S E R V I C E N O T E

85942A Video Signal Monitor

Line Module Wire-Routing Modification

Figure 1

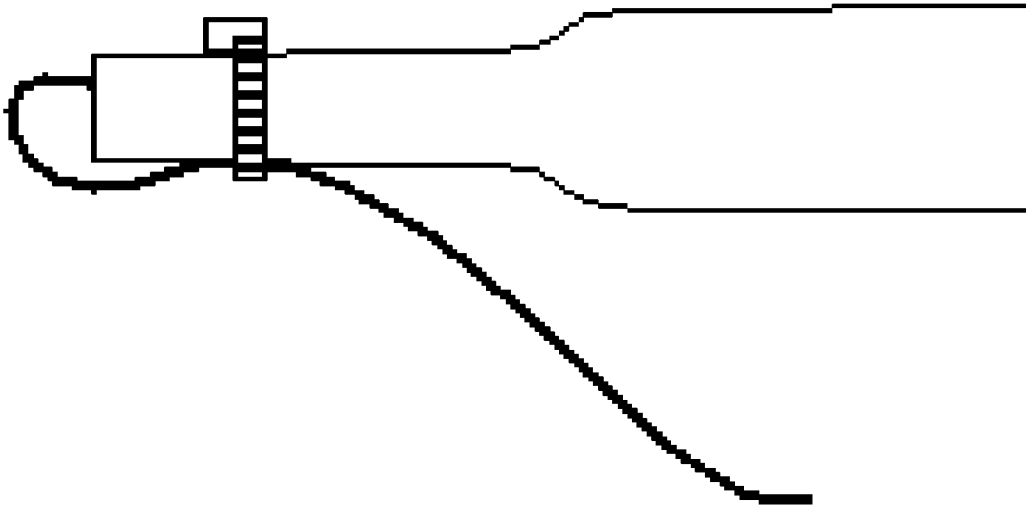
These instruments have two wires that come out of the power supply line module and go to the power supply assembly. With the current routing, these wires pass close to capacitor C25 on the power supply assembly. The wires are properly insulated, however, a break in the insulation could conceivably result in a safety problem. This a a MINIMAL risk, but is actioned as a result of a CSA approval requirement.

The wires can be tied back, so that adequate separation between the wires and C25 is maintained. Add one tie-wrap (1400-0249) to the BLUE wire, and one tie-wrap to the BROWN wire. Attach to each wire, as shown in Figure 1.
